RE: Resolution Copper Mine Project and Land Exchange DEIS

The above groups wish to thank the U.S. Forest Service (USFS) for the opportunity to comment on the Resolution Copper Mine (RCM) Project and Land Exchange Draft Environmental Impact Statement (DEIS). As you are aware, these groups submitted detailed scoping comments for the project on July 18, 2016. These comments are also intended to address the Draft Practicability Analysis In Support of Clean Water Act 404(B)(I) Alternatives, prepared by Westland Resources on Behalf of Resolution Copper for the U.S. Army Corps of Engineers (Corps) as well the proposed 404 permit application and Corps review.

The DEIS is deficient in numerous critical areas, fails to provide a full range of reasonable alternatives, fails to provide a full analysis of the impacts of those alternatives, fails to apply the full scope of federal laws applicable to the project, improperly regulates/reviews the mine under assumed “rights” under federal mining laws without the required factual support, fails to take the required “hard look” under NEPA, and otherwise violates federal law. The USFS/Corps must

Figure 2: Prucha, “Modified Conceptual” West-East section through future fractured crater.

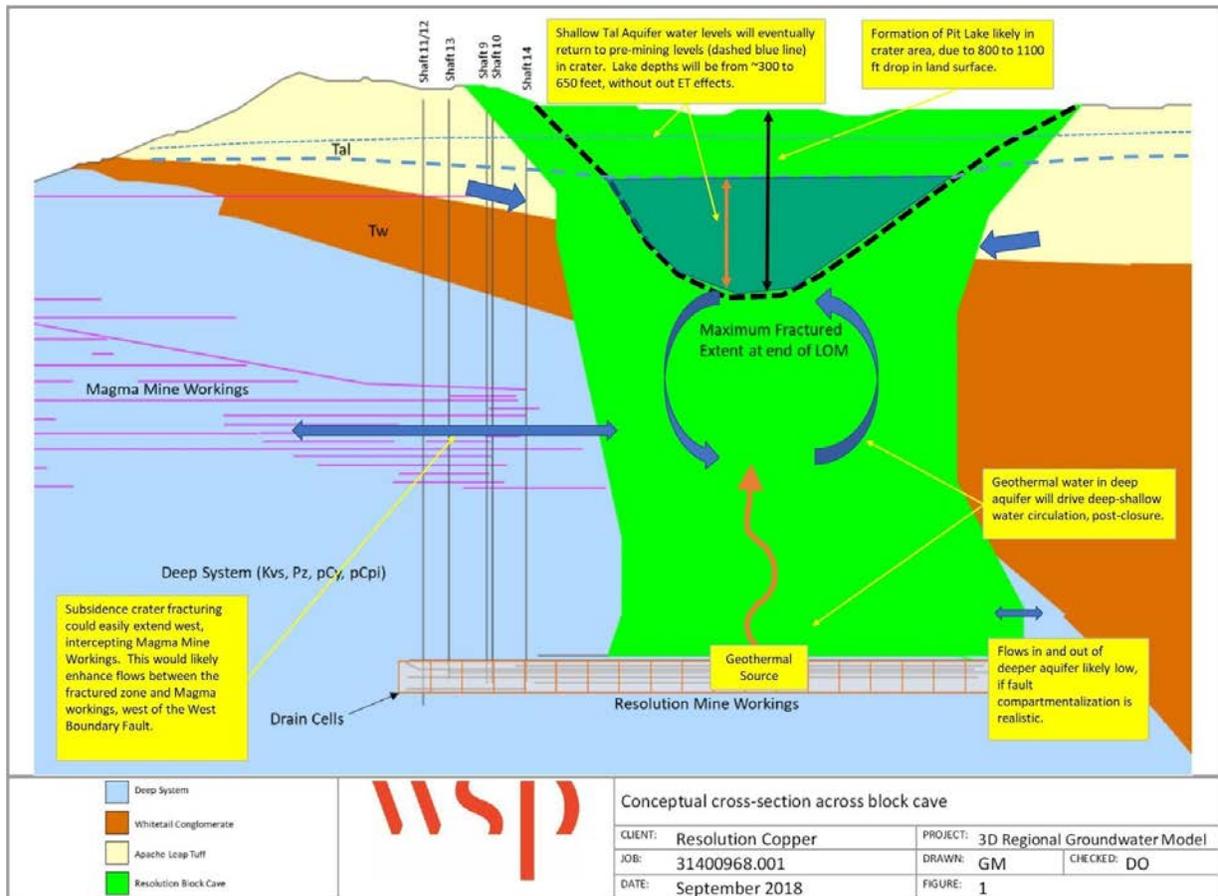
3. Figure 1 from Meza-Cuadra, 2018 was revised to reflect conceptually what the WSP, 2019 groundwater model should have simulated (change in land surface), and the eventual development of a pitlake as groundwater levels recover. WSP should have included this type of Future Processes Conceptual Model, which is industry standard (see Potential Errors in Conceptual Modeling, Section 4.6 in Wels, 2012⁹). Rosemont DEIS groundwater modeling of the development of a pitlake was developed using Modflow-Surfact coupled to a dynamic systems model using the GoldSim code (Roemer, et al., 2018).

Modified conceptual West-East section through future fractured crater. Note it shows no adjustment to land surface. Recovered water levels and revised ground surface added.

Figure 3: Prucha “Long-term Draw-Down”: Long-term Drawdown (greater than 1 foot) likely extends several kilometers out in all directions (Red zone shows 4 km buffer around 10 foot maximum drawdown area in DEIS. Blue areas are SW Quantity Analysis Areas (from Figure 3.7.3-1 in DEIS).

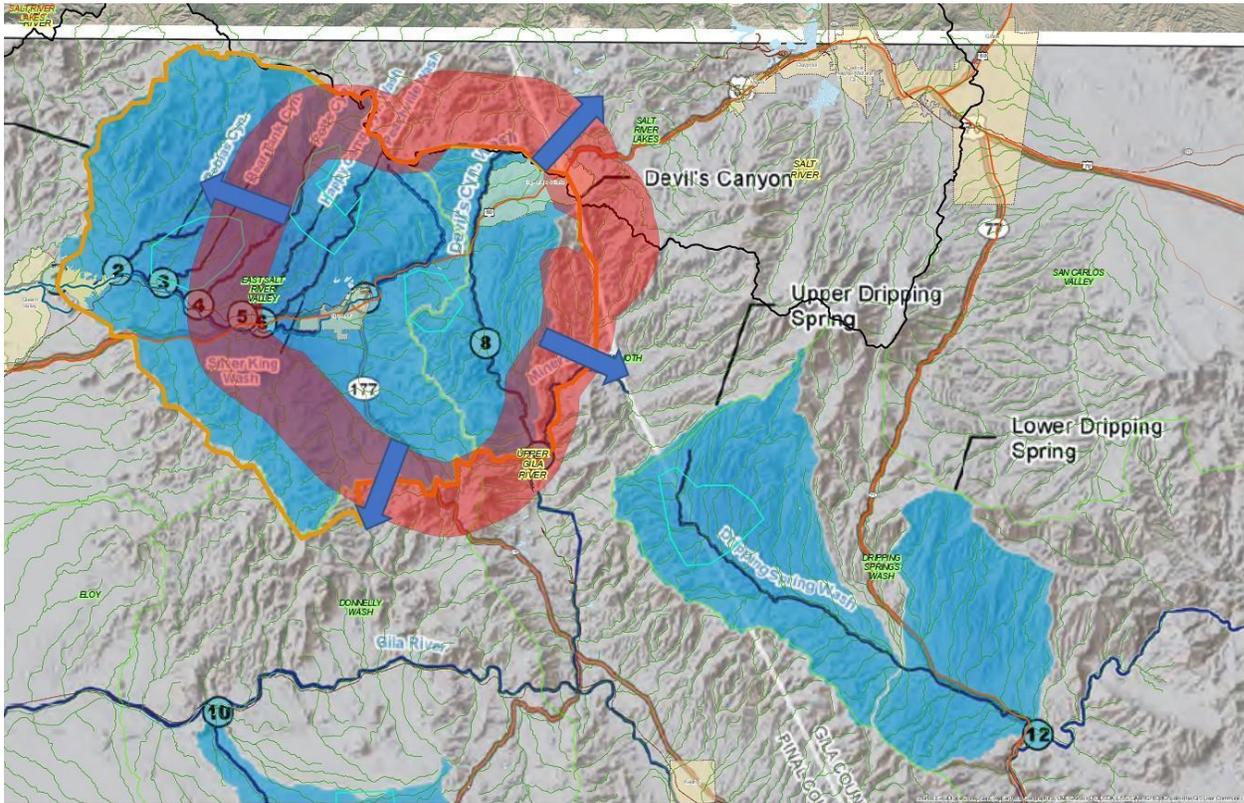
“Long-term Draw-Down” below shows a more likely long-term drawdown (at steady state, not arbitrary 148 years after closure) 4 km out from the arbitrarily chosen 10’ drawdown, which should really have shown predicted drawdowns of <1’, or something which would impact groundwater discharge areas (springs, baseflow in streams, riparian vegetation etc). The figure shows that additional SW areas would likely be affected by long-term drawdown than evaluated in the DEIS. The DEIS should have also assessed impacts within the following watersheds:

- North of Queen Creek, including Haunted Canyon, Upper Pinto Creek, and West Fork watersheds.
- Walnut Canyon to the south, which drains into the Gila River via Donnelly Wash.

Figure 4: (Figure 3.7.1-2. from DEIS) Desert Wellfield modeling analysis area and maximum (Alternative 2, left) and minimum (Alternative 4, right) modeled pumping impacts.

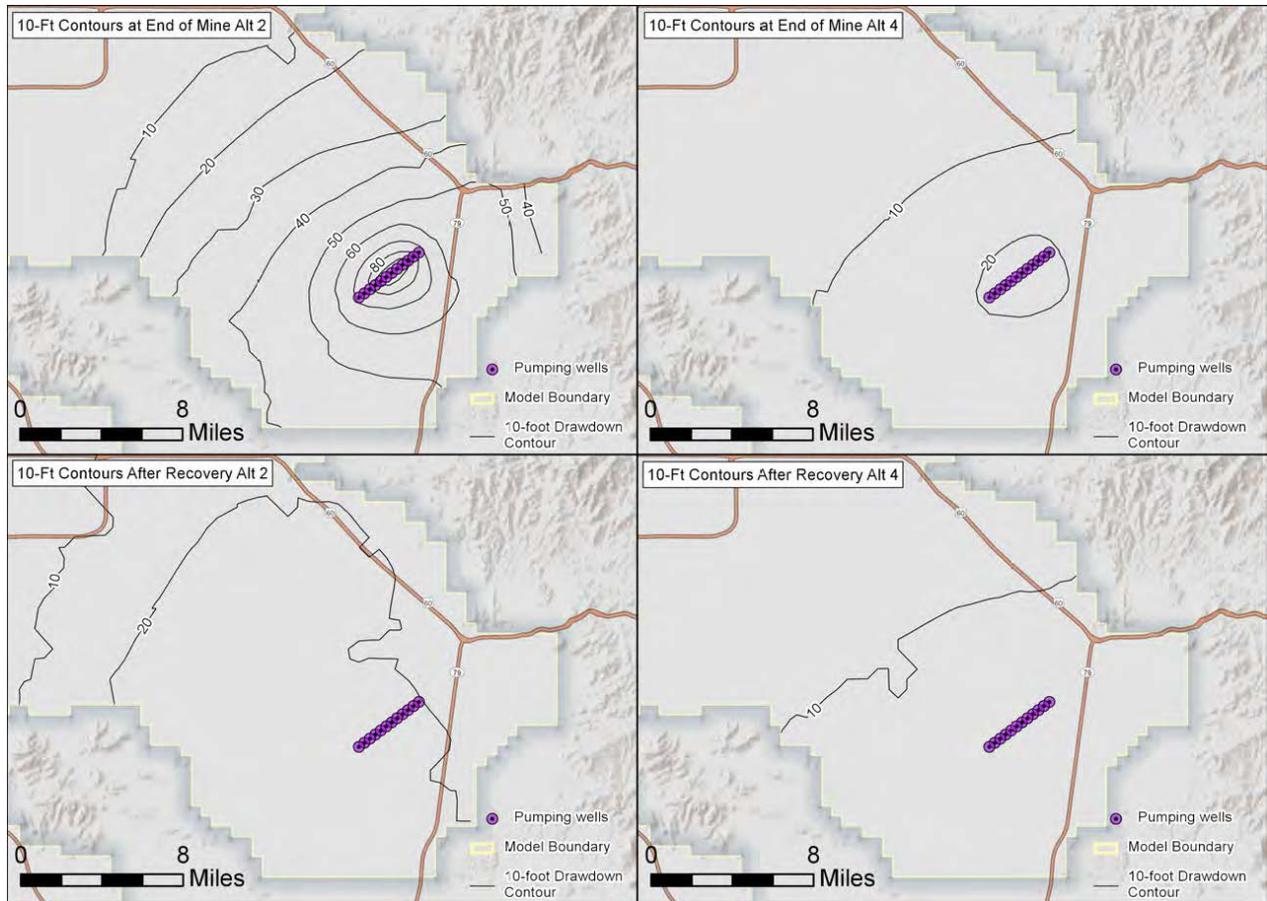
wildlife, impacts to existing and planned infrastructure, etc.) are all absent from the DEIS. Drawdown contours are shown in Figure 3.7.1-2 (DEIS p. 298) which overlay nearby roadways and developed areas, but the impacts of these drawdowns on those features are never analyzed in the DEIS.

A map (or discussion) of the groundwater model area boundaries for the East Salt River Valley analysis area are never provided. The DEIS (p. 298) claims that figure 3.7.1-2 shows the groundwater model boundaries/analysis area of the East Salt River valley model. However, figure 3.7.1-2 (p. 298), below, shows only a zoomed-in, limited portion of this groundwater model area – making it impossible to know what the analysis area does or does not include.

Figure 5: (Figure 3.7.1-1. from DEIS) Overview of groundwater modeling analysis area

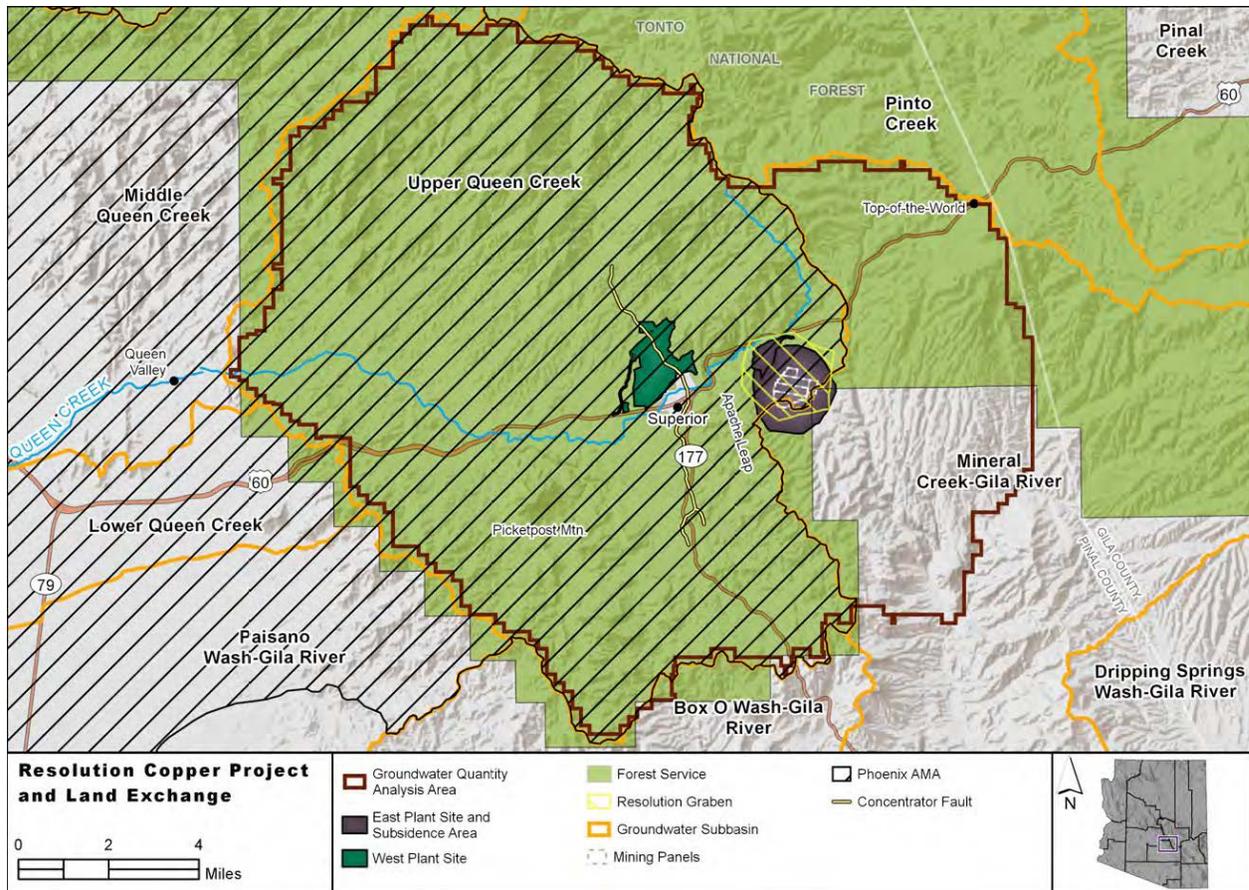
As shown below, the analysis area of the water quality model omits critical segments of Queen Creek. Figure 3.7.2-1 shows what is included in the water model analysis area studied under this section (supposedly encompassing where groundwater or surface water quality changes could potentially occur under the project). The area studied is extremely insufficient for many reasons,

including that only about half of the length of Queen Creek between the block-cave zone and Whitlow Dam is included in the analysis area, despite Resolution Copper having an AZPDES permit No. AZ0020389 for nearly ten years to discharge mine wastewater into the unstudied portion of Queen Creek. The DEIS does not address why this study failed to include such a large portion of Queen Creek, but this is an extremely unscientific, glaring omission which fails to comply with the requirements of 40 C.F.R. § 1502.16 and the very first requirement on the list of requirements for an EIS at Section 102(2)(C) of NEPA (P.L. 91-190).

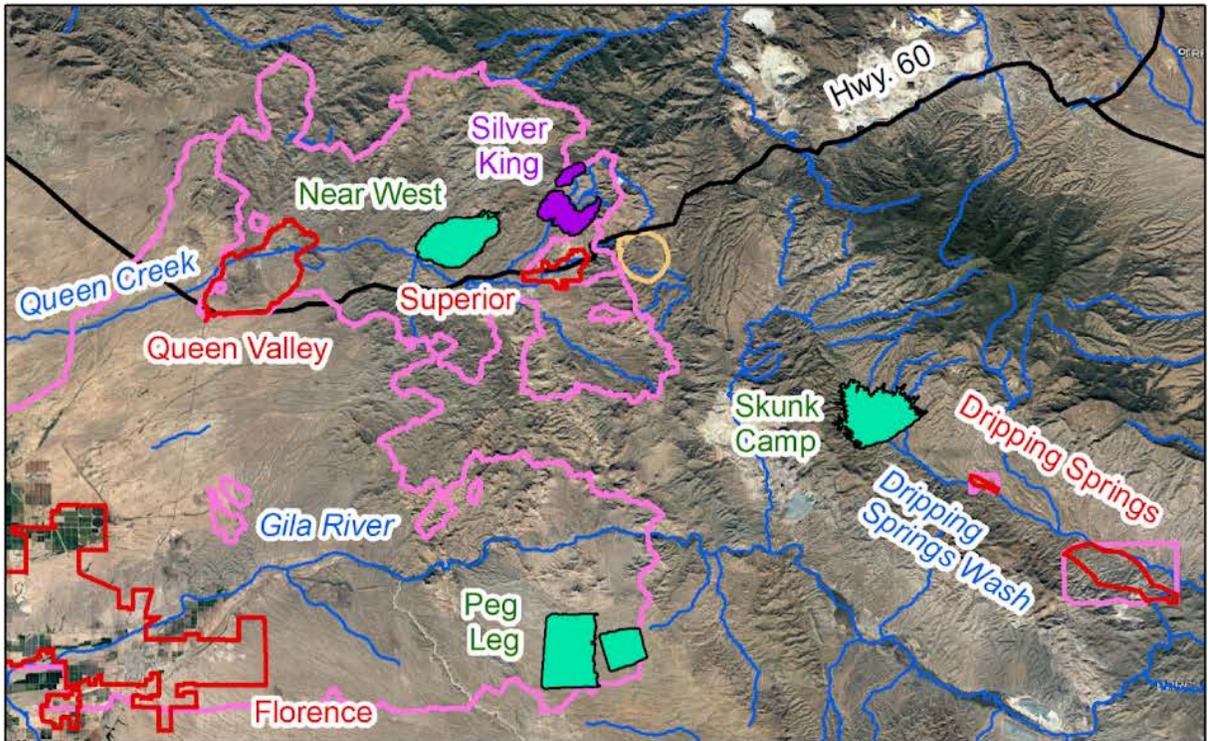
The most important aspect of the design of the tailings dam, or any other component of a tailings storage facility, is the choice of the correct safety criteria, one of which is the Maximum Design Earthquake (MDE). According to Rio Tinto, the tailings storage facilities will be designed to withstand an earthquake with a return period of 5,000 years, corresponding to an earthquake with an annual exceedance probability of 0.02%, or a 1% probability of exceedance in 50 years (Resolution Copper Mining, 2014a,c). That choice of the 5,000-year earthquake has never been justified in any document produced by Rio Tinto.

Springs (population 235) would be impacted by the failure of the Skunk Camp facility. On the above basis, the tailings storage facilities should be designed to withstand the Maximum Credible Earthquake, rather than the 5000-year earthquake, as proposed by Rio Tinto. Background combines Google Earth imagery from December 6, 2014, January 13, 2018, and April 6, 2018.

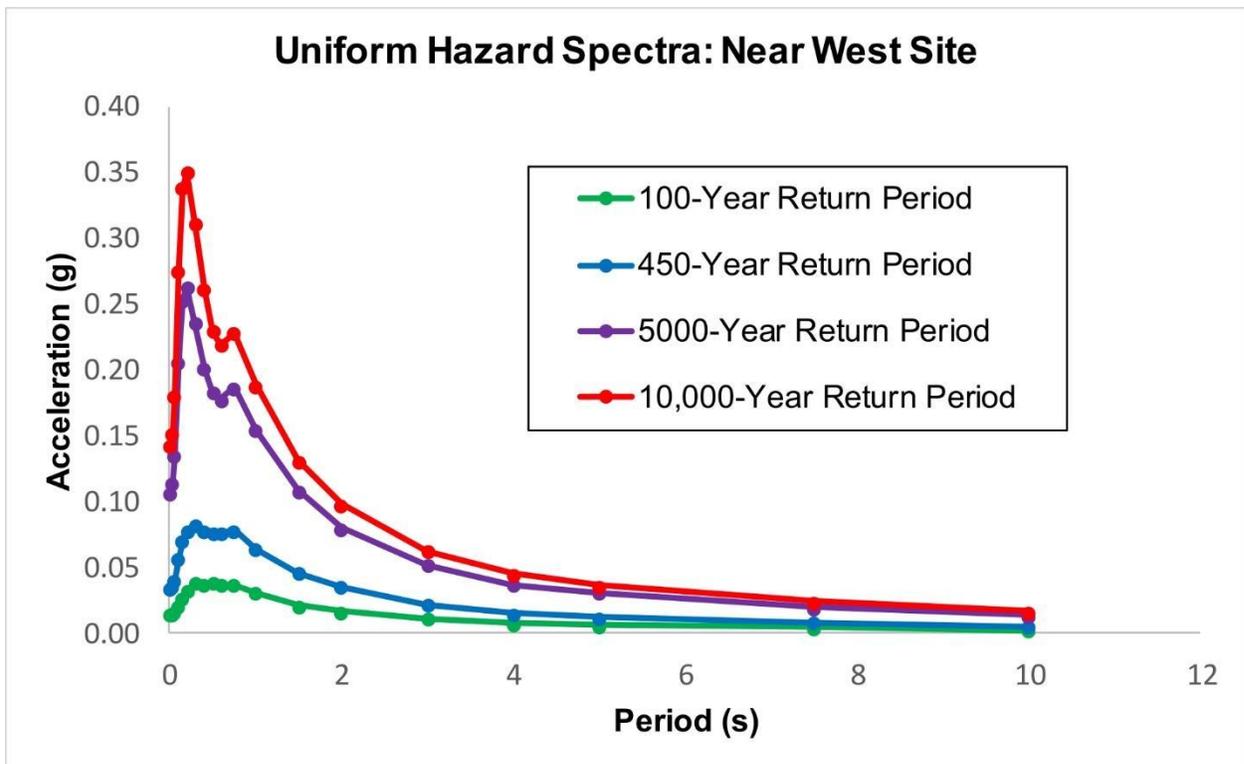
It should now be abundantly clear that, due to the probable loss of human life that would result from failure of the tailings dams, the Maximum Credible Earthquake (MCE), and not the 5000-year earthquake, is the appropriate design criterion for the proposed tailings storage facilities. The only remaining question is the additional cost of construction and operation of the facilities that would be necessary to accommodate the strengthened safety standard. The higher safety standard is not a minor change. Based on calculations presented in Table 3 of Appendix I in Resolution Copper Mining (2014c), at the Near West site, the predicted acceleration that would result from a 10,000-year earthquake is considerably greater (factor of 1.16-1.34 over the range 0.01-10 seconds for periodicity of seismic shaking) than what would result from a 5000-year earthquake (see Fig. Emerman, “At the Near West Site”) In fact, the predicted accelerations show no signs of approaching an asymptotic limit as the earthquake return period is increased from 100 years to 10,000 years (see Fig. Emerman, “At the Near West Site”)

The additional costs should be considered in light of the common causes of failures of tailings dams during earthquakes. Most failures are a result of some form of liquefaction of either the foundation, the tailings dam, or the tailings stored behind the dam. Under normal circumstances, although there is water in the pores between the solid particles within the soil, tailings or tailings dam, the particles are touching one another, so that the overlying load is carried by the solid particles (and partially by the water). However, during seismic shaking, the particles can separate, so that they are no longer touching one another, and all of the load is carried by the interstitial water. Since water has no shear strength, the soil or the mass of tailings and water behaves as if it were a liquid. Regardless of the method of dam construction, the foundation could be potentially liquefiable during an earthquake. If that is the case, the foundation might require appropriate compaction prior to dam construction, or the liquefiable foundation material might need to be removed and replaced with more appropriate material, or it might be necessary to choose a different site.

Figure 12 (DEIS 2019) Predicted crater (blue) and fracture limits (black) at the end of mine life.

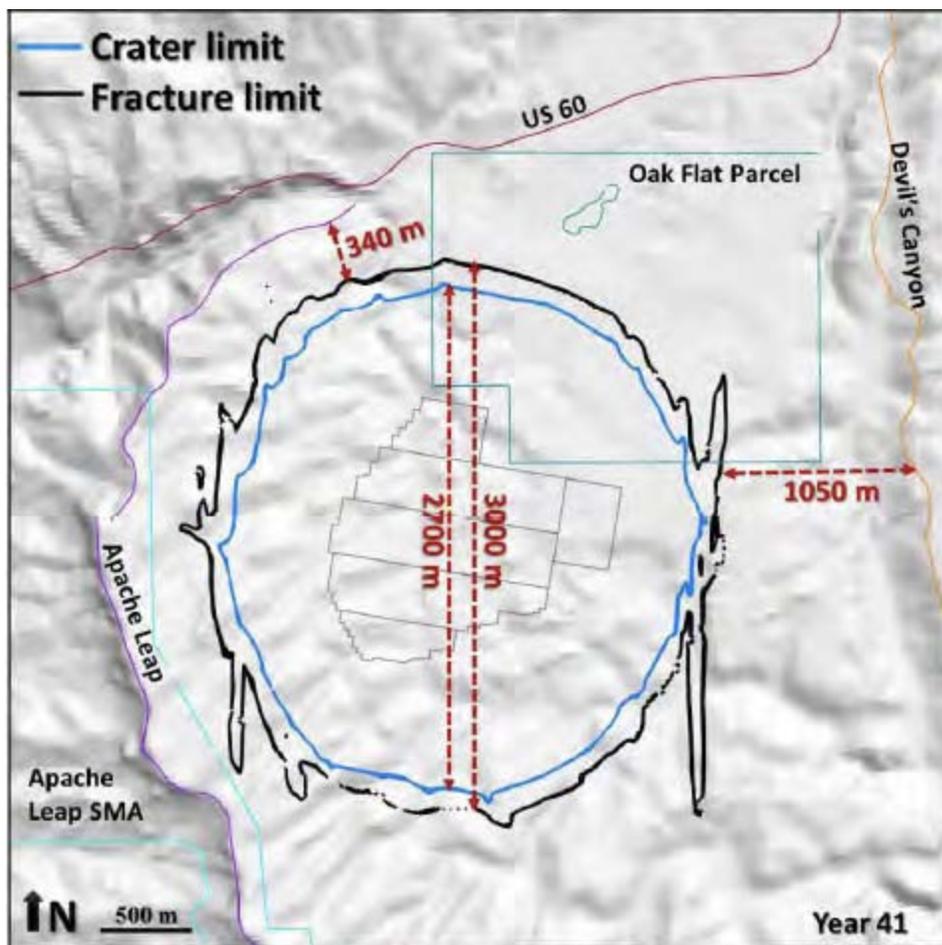
Mining is predicted to result in a “Large, visible crater with cave angles of 70 to 78 degrees and with a depth between approximately 800 and 1,115 feet at the end of mine life ... the fracture limit is estimated to extend to within approximately 1,115 feet (340 m) from Apache Leap, and to approximately 3,445 feet (1,050 m) from Devil’s Canyon. The fracture limit area is roughly 1.8 miles in diameter.” (DEIS 2019).

It should be noted that if the subsidence angle turns out to be less than the 70 to 78 degrees predicted, especially after mining ceases, the fracture zone shown in Figure 16 (DEIS 2019) would move closer to Apache Leap. Any mining of a deeper resource, if done by block caving, the only method considered by Resolution Copper, the fracture zone would likely also widen. As a result, a significant part of the deeper resource would need to be sterilized to protect Apache Leap. With underground backfill this significant part of the resource could be mined. Underground mining with backfill was inappropriately eliminated from consideration as an alternative because the impacts that could be avoided were not given proper consideration. In addition, the Forest Service expert undervalued the orebody, and dry tailings for backfill is technically feasible as the Forest Service approval of Rosemont clearly demonstrates.

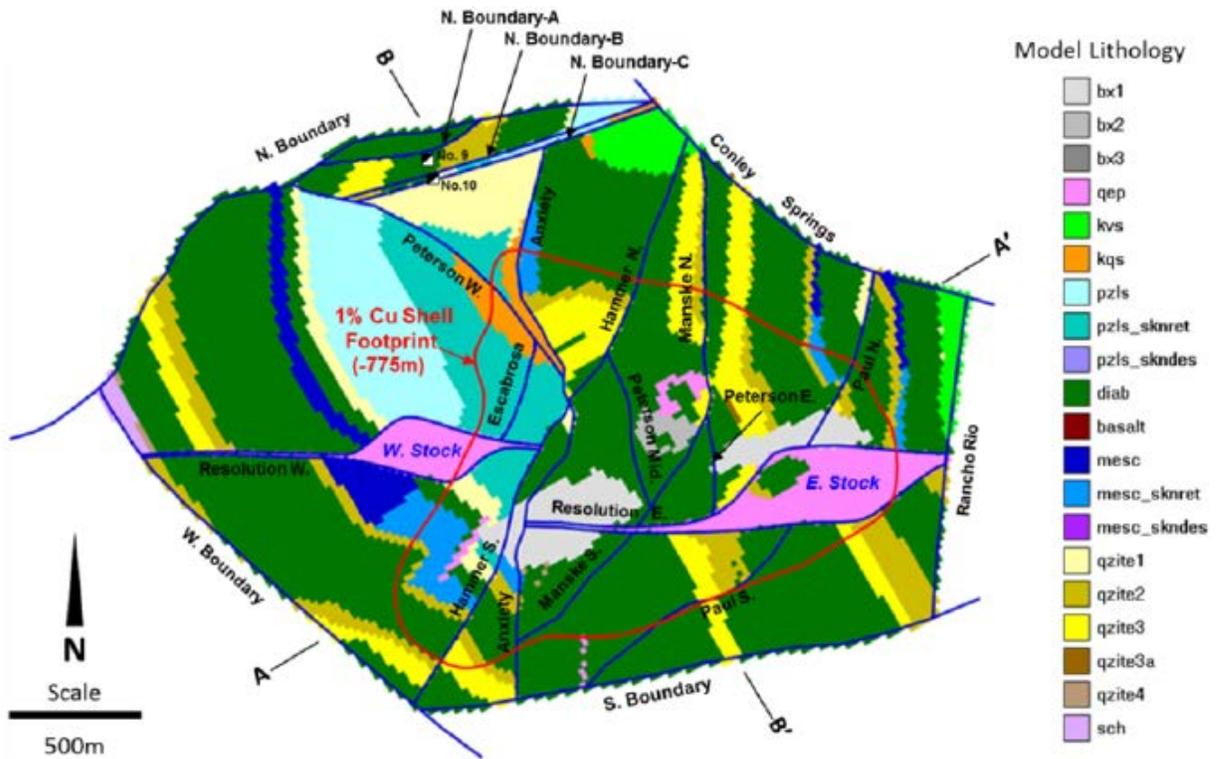
depths of the drill cores. Clearly, a valid subsidence model requires an adequate number and distribution of samples, which cannot be assessed. The geotechnical properties of the deepest layers (or geotechnical domains) can have a great influence on the extent of the subsidence zone on the surface (see Fig. Emerman, “The Subsidence Zone”). However, there is no information as to how many or whether any of the drill cores penetrated as deeply as the No. 10 Shaft (the 6943-foot deep primary access shaft).

The only exception to the above-mentioned lack of input data is the map of the geological faults that were used in the subsidence modeling (see Fig. Emerman, “The Most Important”). The faults and other zones of weakness should be the primary control on the surface expression of
